NL-08-1124

**Joseph M. Farley Nuclear Plant - Units 1 and 2
License Amendment Request to Technical Specification 3.9.3,
Containment Penetrations, Personnel Air Locks Doors Open During
Fuel Movement – Response to Request for Additional Information**

Response to Request for Additional Information

Southern Company Services, Inc. for
ALABAMA POWER COMPANY
 PROJECT: 220, FAYLEY NUCLEAR PLANT - UNIT NO. 2
 ARCHITECTURAL - CONTAINMENT AND
 AUXILIARY BUILDING FLOOR PLAN EL. 155'-0" & 165'-0"
 DRAWN: M. MALDUM DATE: 12/18/72
 CHECKED: DATE: 3/32 = 1'-0"
 SCALE: 1" = 1'-0" D-206006

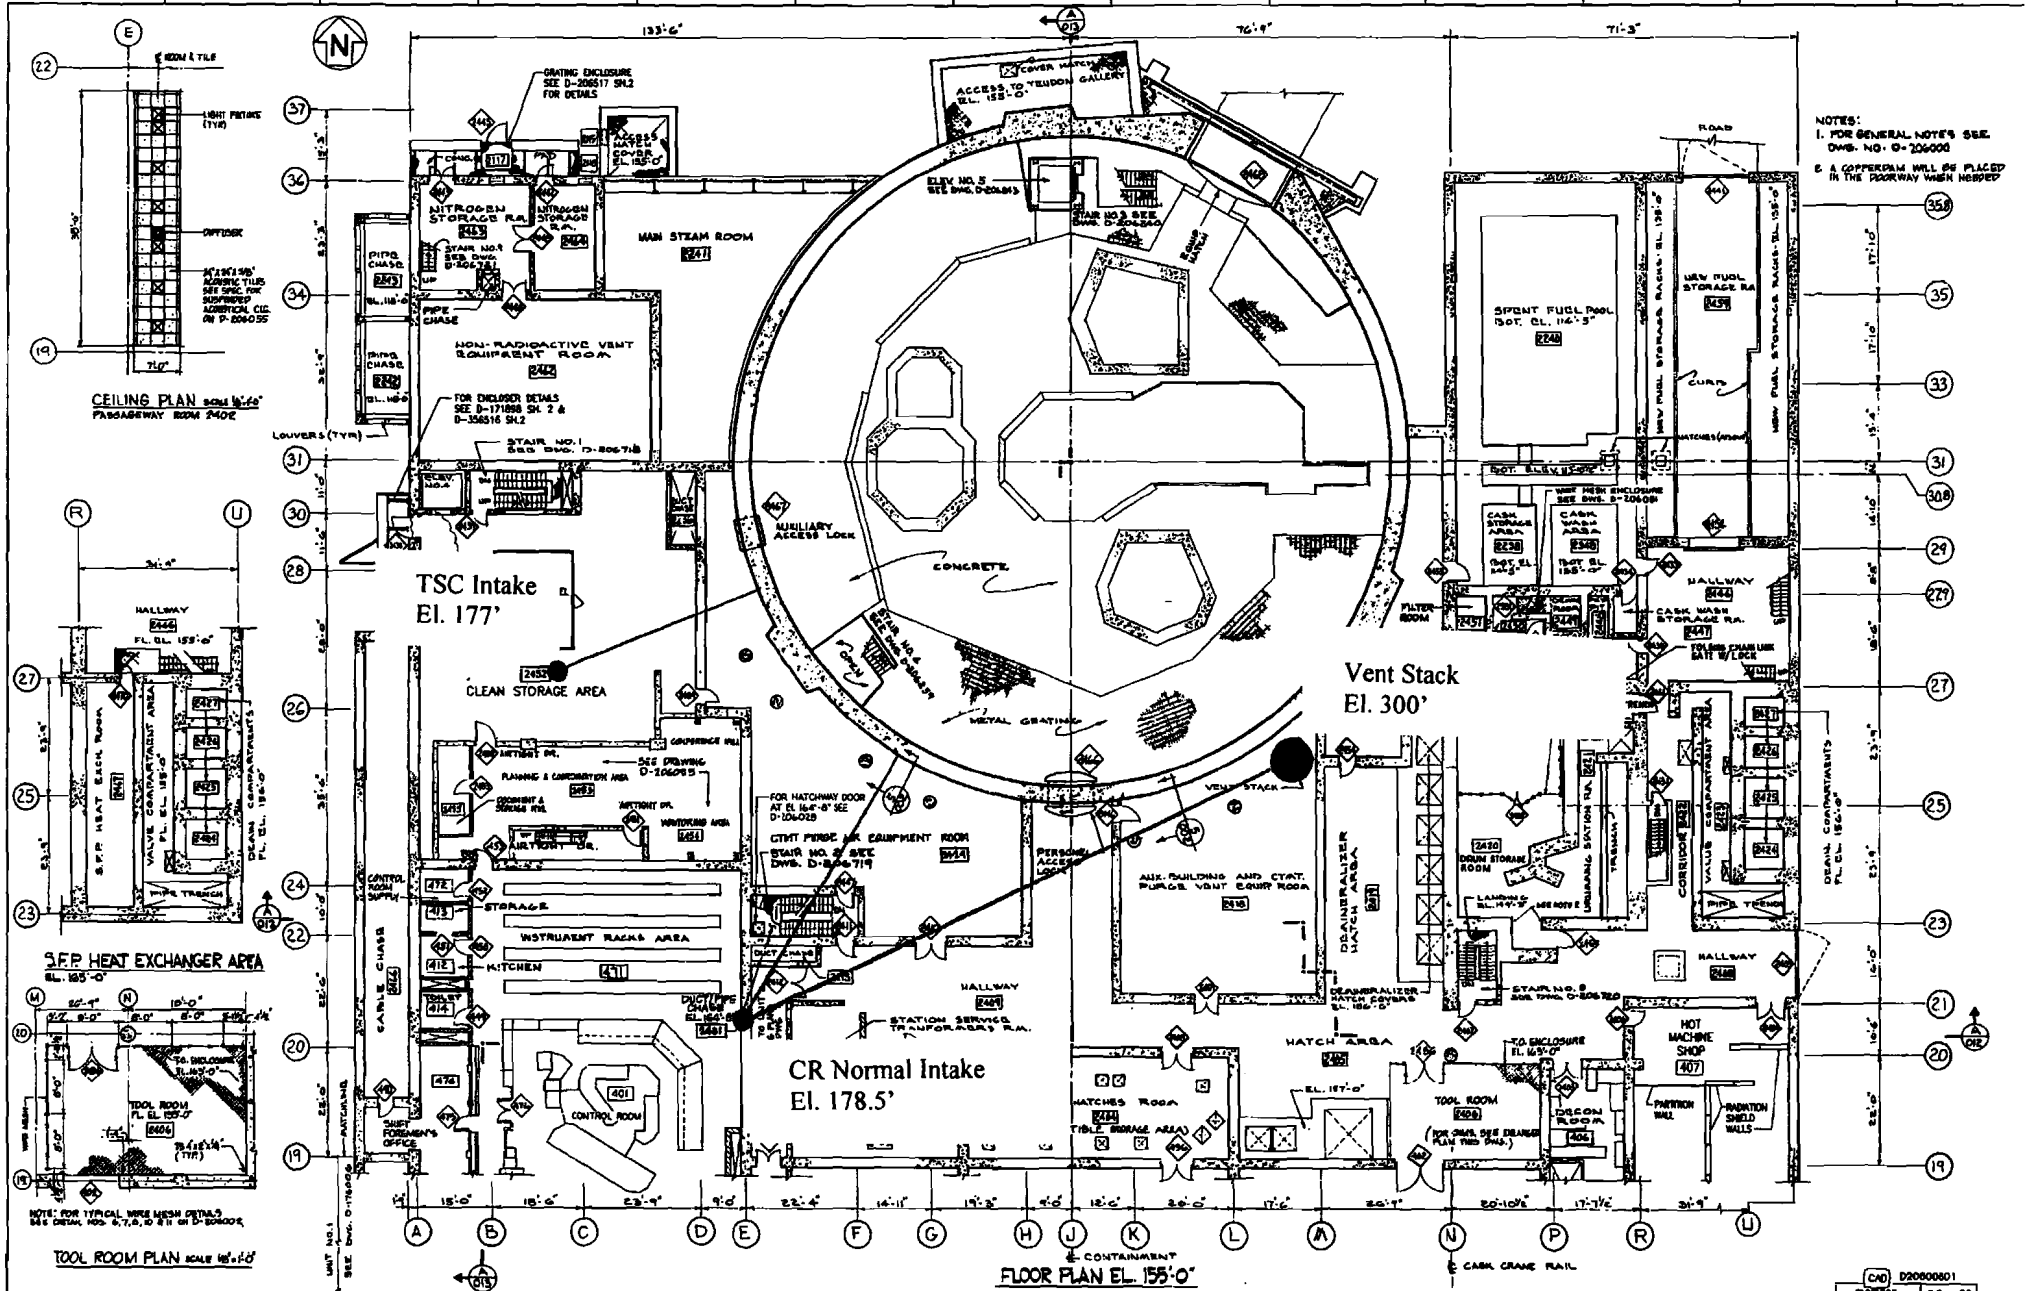
2. Section 3.1.1.2 of Enclosure 1 states that the release from the containment personnel air locks into the auxiliary building is picked up by the auxiliary building rad-side ventilation system and vented out the auxiliary building through the plant vent stack. Item 1 on page 8 of Enclosure 1 states that the normal control room air intake is closer to the release pathways as compared to the control room emergency air intakes, but bounded by the Unit 2 to Technical Support Center (TSC) intake location. When the control room is isolated, the control room normal air intake and the TSC intake are closed.

Atmospheric dispersion factors were provided for assumed releases from the Unit 1 and Unit 2 vents, equipment hatches, and reactor building walls to the TSC intake and to the emergency air intakes, but not to the control room normal intake. The licensee stated that the normal control room air intake is closer to the release pathways as compared to the control room emergency air intakes, but bounded by the Unit 2 to TSC intake location. Thus, the routine outside air makeup through the normal air intake can be represented by the Unit 2 release locations to the TSC air intake χ/Q values for the fuel handling accident. What are the distances and directions from the Unit 2 vent and the closest location on the Unit 2 reactor wall to the normal intake? What is the height of the normal intake? What is the scale of Figure 2 of Enclosure 1? Is the direction shown true north?

The North direction shown on the various drawings provided in the SNC April 27, 2008 letter is true north; however, the drawings are diagrammatic and not-to-scale. A scaled, dimensioned markup is attached showing the dimensions and elevations of the Unit 2 plant vent stack, TSC intake, and normal CR intake. The drawing provides directions and distances between the release and intake points as described below.

Reactor Bldg - TSC Reactor Bldg - CR Normal Intake Vent - CR Normal Intake

Horizontal distance (ft) 44.5
 Vertical Distance (ft) 0
 Direction (deg from North) 66

Horizontal distance (ft) 60
 Vertical Distance (ft) 0
 Direction (deg from North) 31

Horizontal distance (ft) 122
 Vertical Distance (ft) 121.5
 Direction (deg from North) 64
